MCPB
Item #
5/31/07

SUBJECT: Long Branch- Walkway-Bridge
Mandatory Referral No. 07901-DH&CA-1

Mandatory Referral No. 07901-DH&CA-1
Long Branch Stream Valley Park - Trail Bridge and Library Sidewalk

SUBJECT: Long Branch Walkway-Bridge Facility Plan

Proposed Alignment.

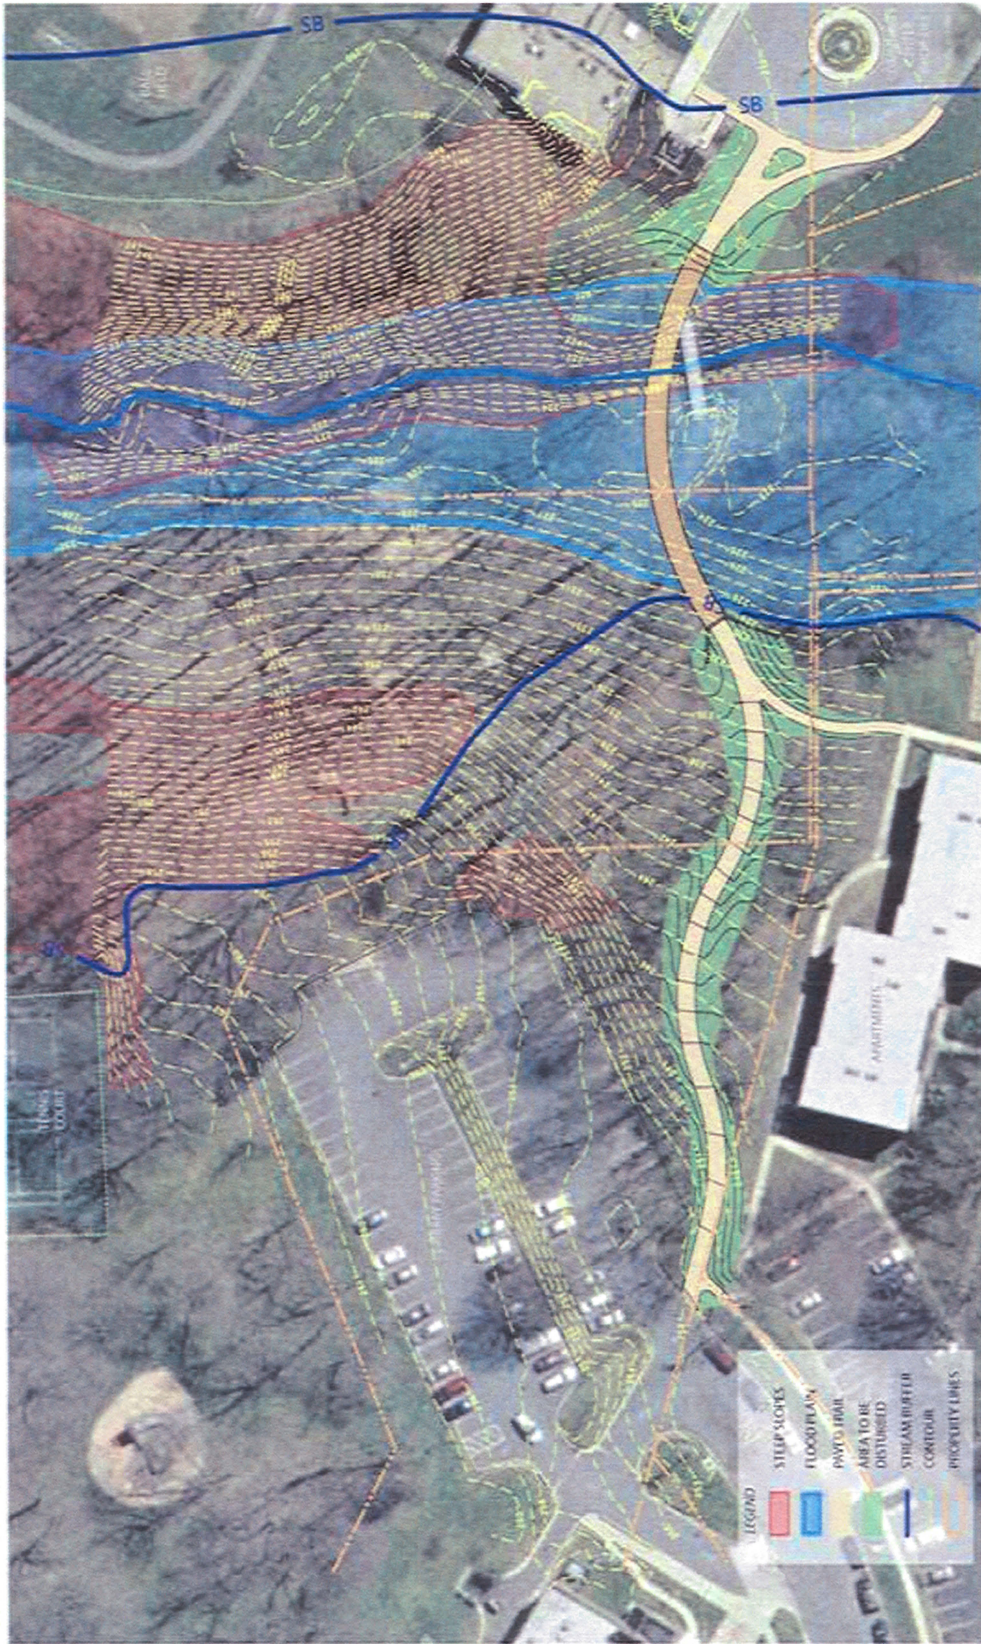
2. Trail – The trail shall be a minimum of 8 feet wide (2% maximum cross slope) with 2-foot grass shoulders (maximum 4% cross slope) on both sides unless otherwise specified by M-NCPPC staff. The trail shall be sited to minimize environmental impacts. A profile of the bridge and trail alignment, showing existing and proposed grades, shall be submitted for review and approval by M-NCPPC staff. All trees, along the bridge and trail alignment, shall be limbed up to a minimum 12-foot height to provide for free travel of both police cruisers and maintenance trucks. The trail and bridge shall be built to meet American Association of State Highway and Transportation Officials (AASHTO) as well as the Americans with Disabilities Act (ADA) standards. A striped crosswalk and curb ramp shall be provided at the trail entrances to meet the Department of Public Works and Transportation standards to connect the trail to the Long Branch Library and Community Center sidewalk. Prior to Park Permit, a Trail / Signage Plan shall be reviewed and approved by the M-NCPPC staff. Signage shall be provided as required by M-NCPPC standards, which prohibits unauthorized motor vehicles.

3. Bridge - The bridge shall be designed to be aesthetically pleasing with minimal impact to the natural resources in the park, provide connectivity, and promote safety. Since the bridge will be owned and maintained by the M-NCPPC, the bridge design shall be low maintenance and provide an average life cycle of 50 years.

The 170-foot (approximate) length bridge shall be constructed as a steel stringer bridge, with steel or concrete piers, concrete abutments, and a maximum of two to four spans, unless otherwise approved by the MNCPPC. The steel stringers shall be made of weathering steel and shall be constructed from high-strength, self-weathering, low alloy, atmospheric corrosion resistant steel. The pier locations shall be adjusted accordingly to provide maximum clearance of stream banks. Pedestrian access shall be maintained as much as possible during construction, or alternative routes shall be designated. The floodplain fill soil, presently existing near the park bridge abutments, shall be removed and the existing floodplain shall be restored to its natural grade.

4. Lighting – Prior to Park Permit, a Photometric Plan and Lighting Plan shall be submitted for review and approval by the M-NCPPC. The lighting provided shall maintain the current lighting along the existing trail and bridge for security purposes and facial recognition. Protective coverings shall be provided over the lights to prevent vandalism. The light fixtures shall be no more than 20-feet in height using metal halide lighting with a full cut-off light fixture and a housing shield to reduce sky glow and glare onto the adjacent residential apartments; lighting shall also be vandal resistant. Lighting shall also be integrated into the bridge railing system where possible.

Alternative 2
Long Branch Trail - Stream Valley Park

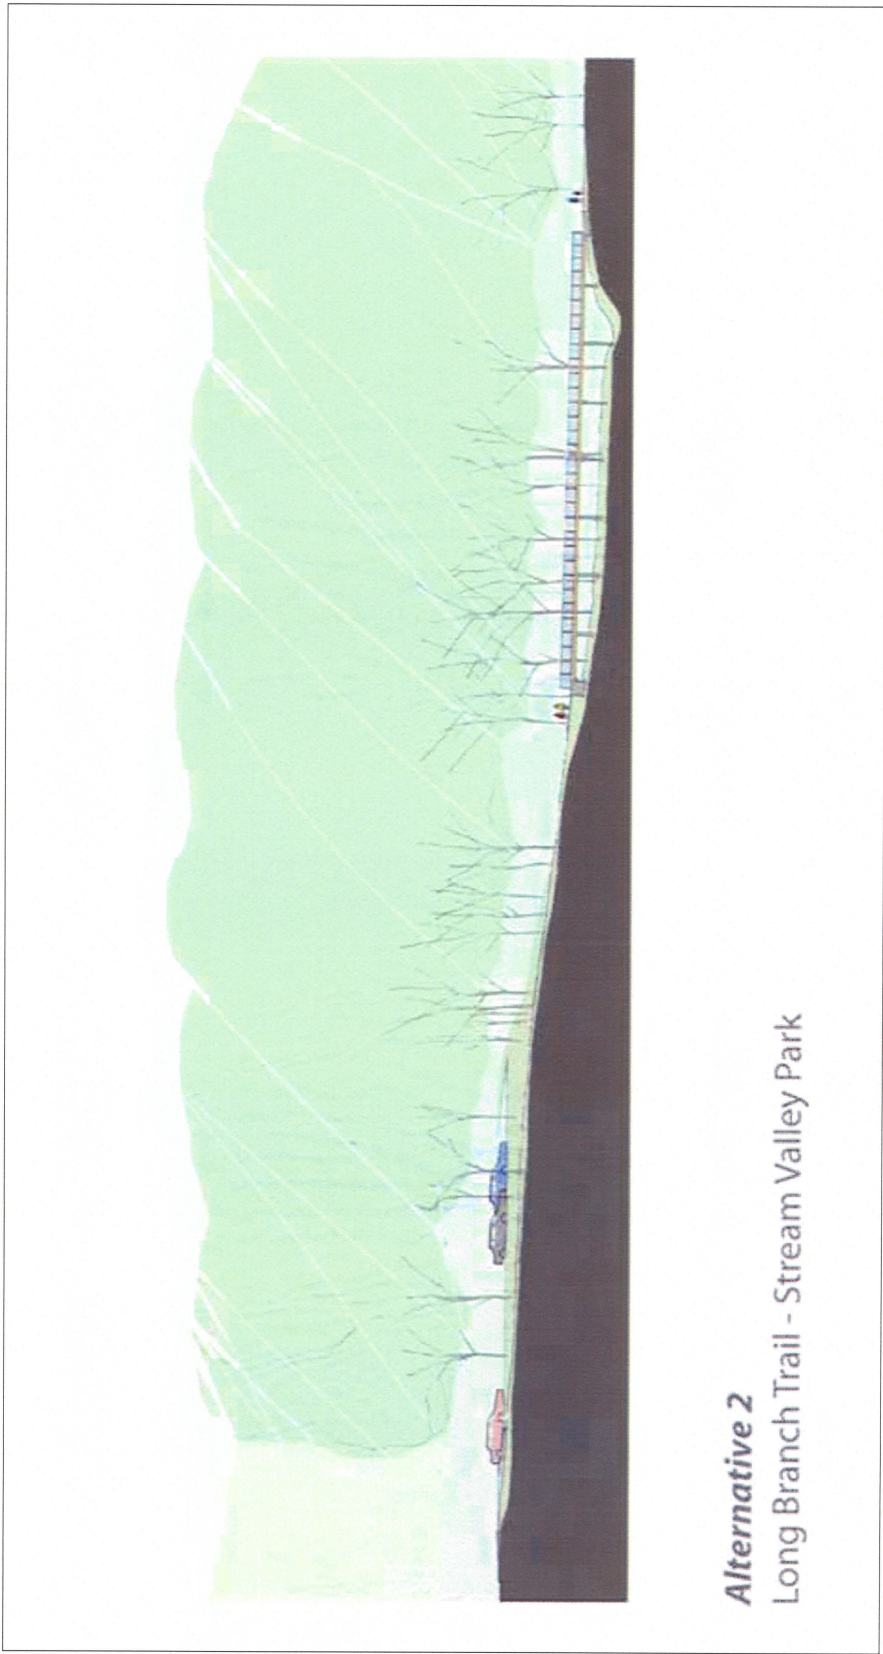
- Tree protection fence shown in detail and in plan on edges of forest where cut is occurring.
 - Tighten grading closer to path and move tree protection fencing about 5' – 10' closer to new path in order to save 28" Tulip Poplar and improve conditions for 48" Tulip Poplar on the north side of the trail.

- Save the 28" Tulip Poplar on the south side of the trail by realigning the walkway leading to the apartments.
 - Remove root pruning in areas of fill.

- Reduce reforestation area shown on Landscape Plan to preserve open view through floodplain for security.

Although subject to change, the submitted plan indicates critical root zone encroachment of greater than 30% to 6 significant and specimen trees. Reducing impact to critical root zones to below 30% using the conditions listed above will greatly increase the probability of preserving two of the trees (28" Tulip Poplar north of trail and 28" Tulip Poplar south of trail).
